STATE OF NORTH DAKOTA
PUBLIC SERVICE COMMISSION

Belle Fourche Pipeline Company
8-Inch Crude Oil Pipeline/McKenzie County
Siting Application

Case No. PU-07-596

ORDER ON REQUEST TO AMEND ROUTE

North Reroute – West of Alexander

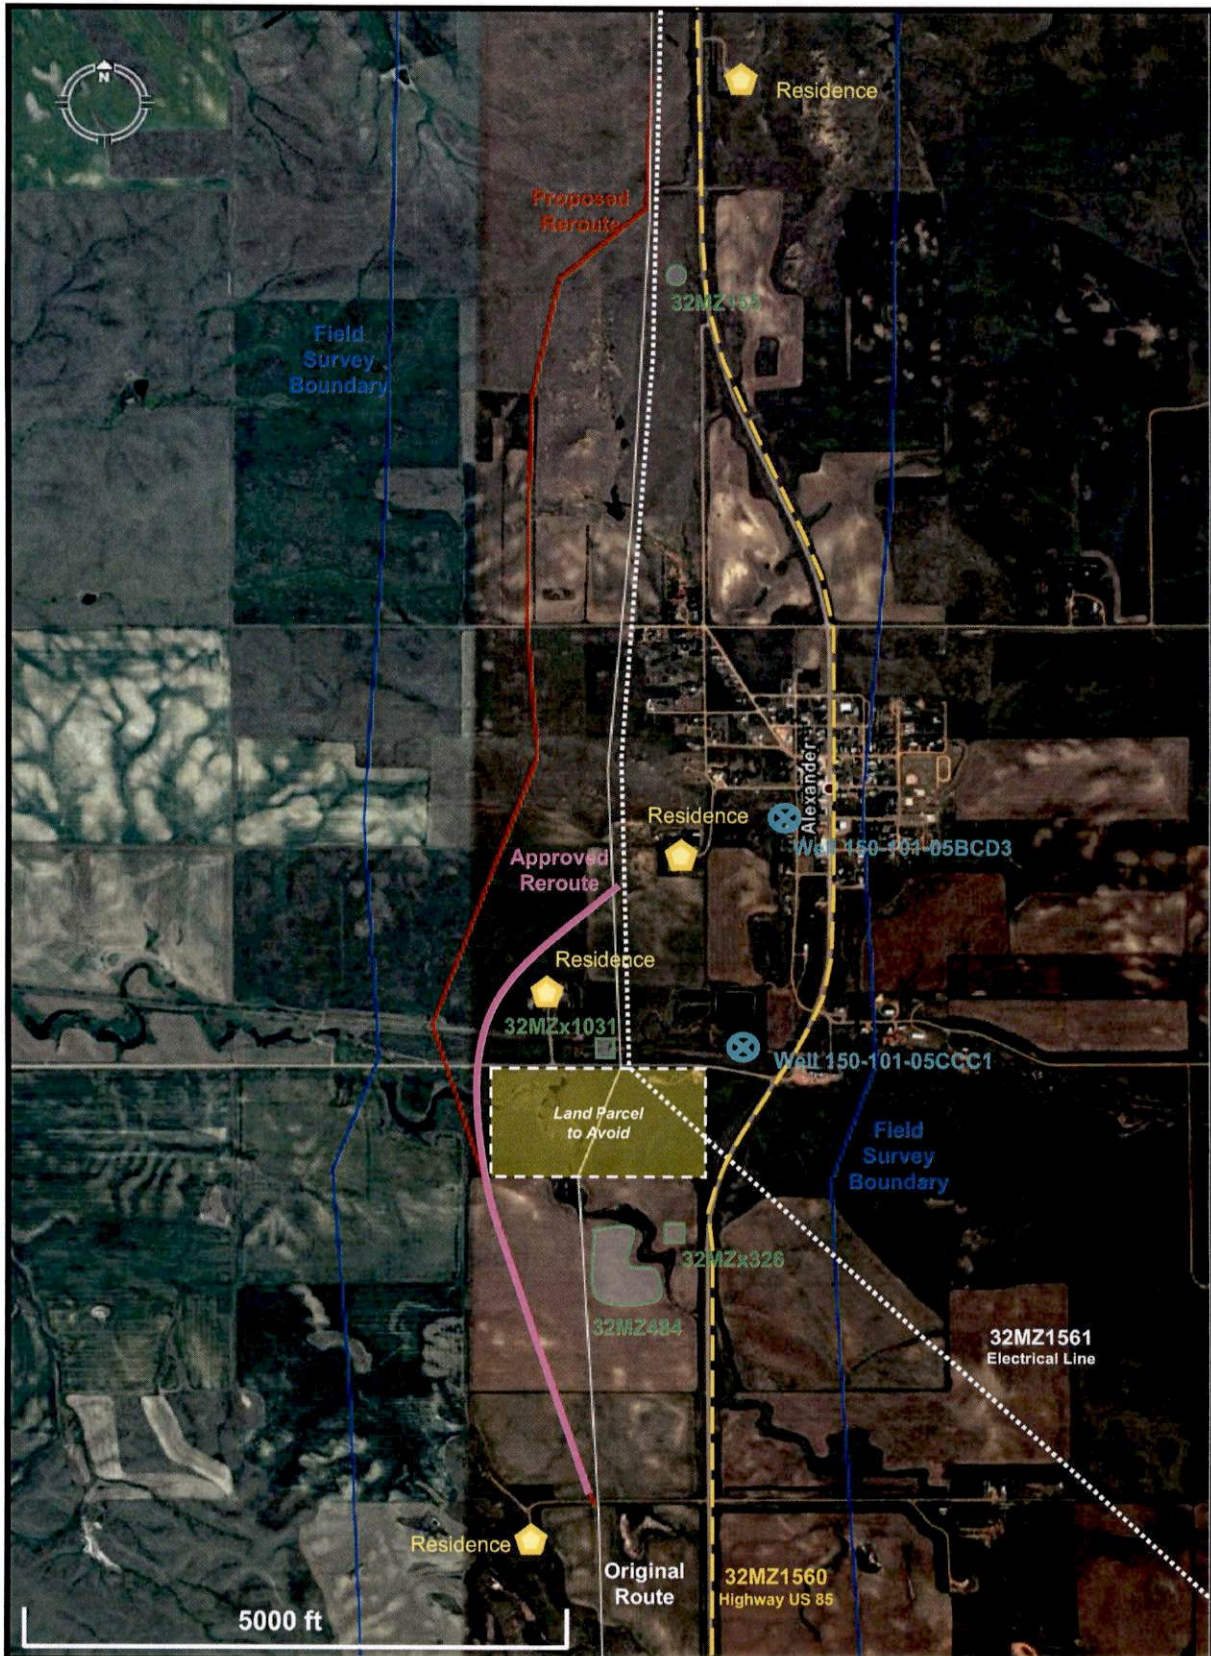
By letter dated January 8, 2008 Belle Fourche requested approval of changes in the original permitted pipeline route at Section 31, T151N, R101W and Section 6, T150N, R101W, in McKenzie County (North Reroute) and at Sections 7 and 18, T149N, R101W in McKenzie County (South Reroute) as shown on the attached maps.

Kathleen Spilman, Managing Director for Keitu Engineers & Consultants, Inc., evaluated the route changes and in a letter dated January 11, 2008 stated the North Reroute was initiated at the request of a landowner and the reroute crosses the property of the same three landowners as the current approved route. All landowners have agreed to the reroute. The North Reroute minimizes potential surface and storm water impacts by avoiding a marshy area of the water crossing, moves the pipeline further away from an occupied dwelling and developed areas of the City of Alexander, avoids routing through a landowner's stock pond and feed lot, and moves the pipeline further away from the municipal drinking wells of the City of Alexander. No new section lines or roads are impacted and a smaller impact to the Lonesome Creek water crossing is

expected. No naturally occurring woody areas or shelterbelt/tree rows or shrub areas are impacted by the reroute. The pipeline would be located even further from archaeological areas of potential exposure.

1. Belle Fourche Pipeline Company's request for changes in the transmission line route in Section 31, T151N, R101W and Section 6, T150N, R101W, and Sections 7 and 18, T149N, R101W, all in McKenzie County is granted.
2. Belle Fourche Pipeline Company is issued First Amended Route Permit No. 108.

South Reroute – 21st Street
Belle Fourche Pipeline
8-inch Crude Oil Pipeline Project
ND PSC Case No. PU-07-596
January 2008 - Revised

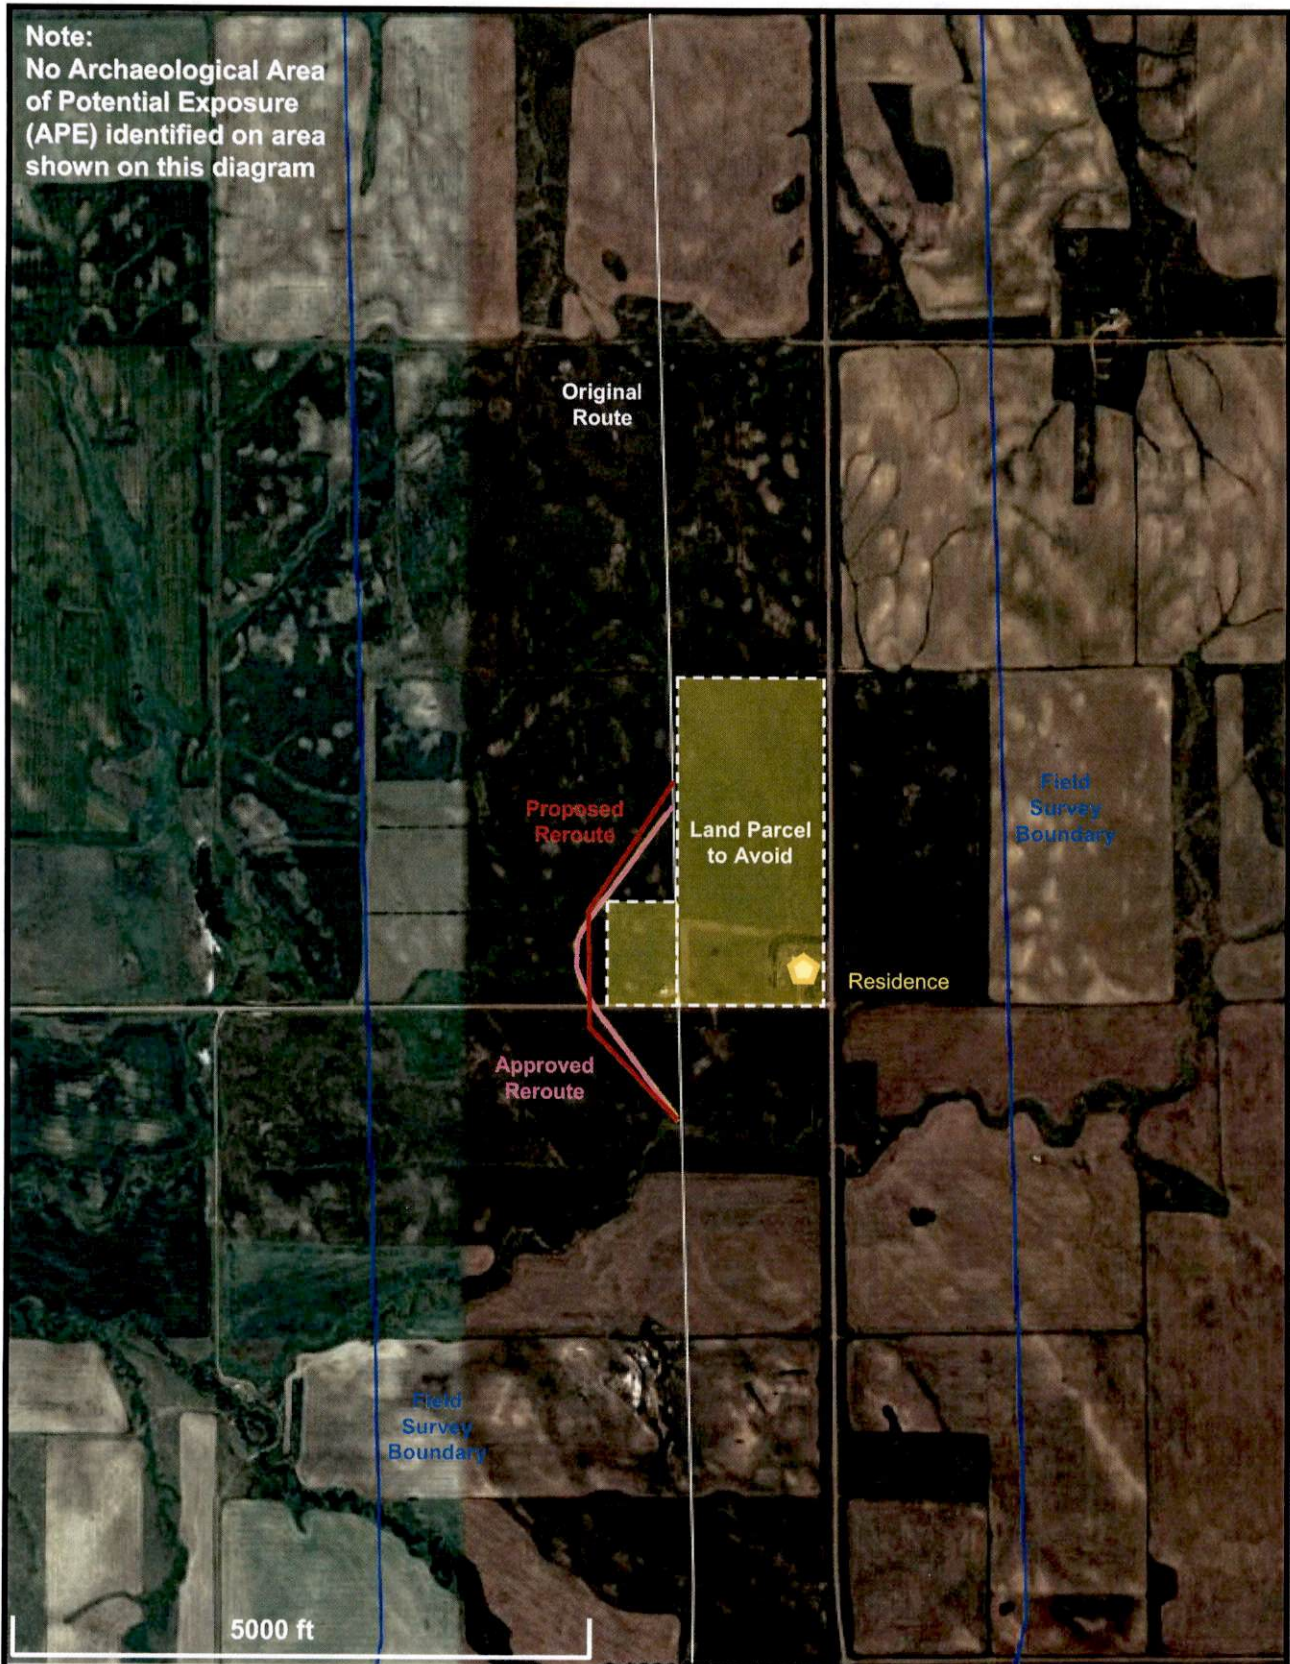
Kathleen Spilman states the South Reroute is proposed to reduce bending and stress on the pipe and increase the distance to the adjacent property line. The South Reroute crosses the property of the same landowners as the current approved route. All rural residences in the area of the reroute are more than 500 feet from the pipeline. No new section lines, roads or water crossings are impacted, no naturally occurring woody areas are impacted, no new shelterbelt/tree rows are impacted, and no archaeological areas of potential exposure are be impacted by the reroute.
